**DTB**

Date: April 23, 2009  
 Order No.: S-B-03.30/08i  
 Supersedes: S-B-03.30/08h dated October 24, 2008  
 Group: 03

**SUBJECT: Model 164.156/172/186/871/886**  
**Model 171.454/456**  
**Model 203.052/054/056/087/092**  
**Model 204.054/056/081/987**  
**Model 209.356/372/456/472**  
**Model 211.056/072/087/090/256/287**  
**Model 216.371/386**  
**Model 219.372**  
**Model 221.171/186**  
**Model 230.471**  
**Model 251.156/165**  
**Equipped with M272 or M273 Engine**  
**Check Engine Light On / Fault Codes Current and/or Stored in ME-SFI Control**  
**Module / Oil Leaking at Camshaft Adjustment Solenoid**

Figure 1 – Damaged/worn S-B-03.30/08a

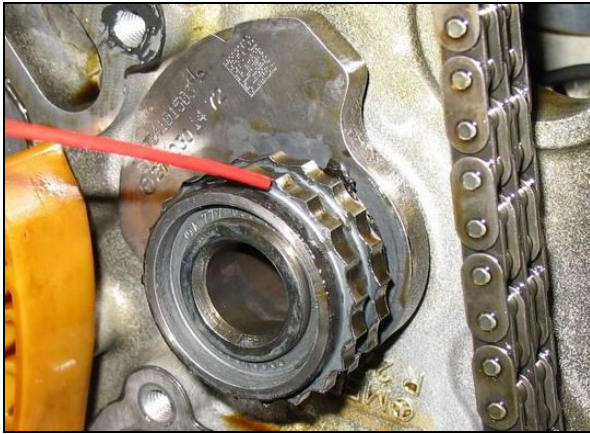
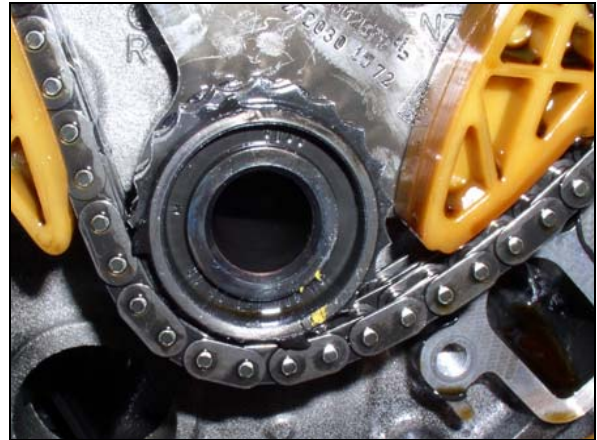
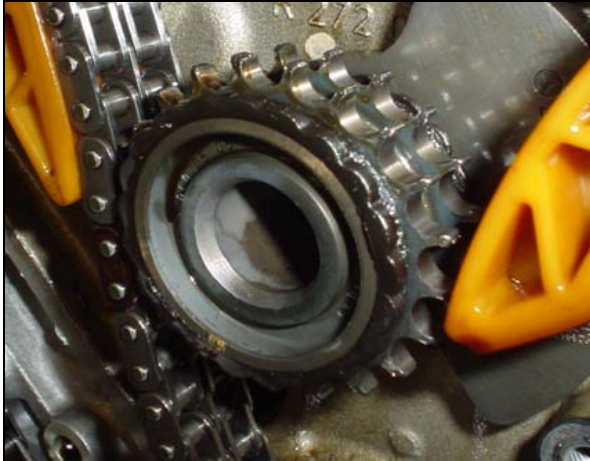
**Fault Code Scenario 1:** DTC 1200 and/or 1208 is/are present in ME-SFI control module. The fault codes are recorded as current and/or stored in the fault memory. When the fault memory is erased and the engine is restarted, the fault codes reoccur immediately. This is due to the positioning of the timing chain driven camshafts relative to the crankshaft and can be caused by a worn sprocket on the balance shaft on engine M272 or by a worn guide (idler) gear for the timing chain on engine M273. Figure 1, 2 and 3 show extremely worn sprocket gears. Figure 4, for comparison, shows a new sprocket gear.

**i** **Note:** Refer to Figure 1 through 3 for examples of damaged / worn sprocket profile. Refer to Figure 4 for example of a new gear (for comparison).

- b) Only if worn (sprocket teeth profile damaged), replace the balance shaft on engine M272 or replace the guide (idler) gear of the chain drive on engine M273 as per WIS instructions AR03.20-P-1000\* (\* - applies to a specific model designation e.g. AR03.20-P-1000VA – model 171).

Figure 5

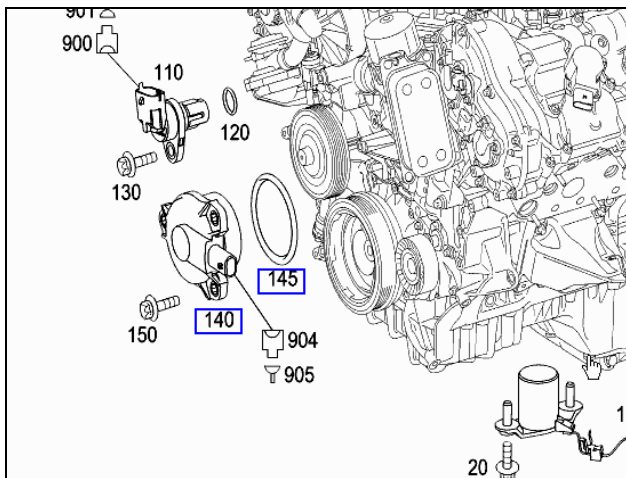
**Fault Scenario 3:** Camshaft adjustment solenoid is leaking oil, and no Fault Codes are current or stored in the ME Control Module. Determine the cause of the leak. The solenoid can be leaking from under the sealing ring or through the harness connector.

- a) If the leak appears to be between the solenoid and the cylinder head replace solenoid sealing ring (Figure 5, 145).
- b) If the leak is from the electrical connector, replace the solenoid (Figure 5, 140).
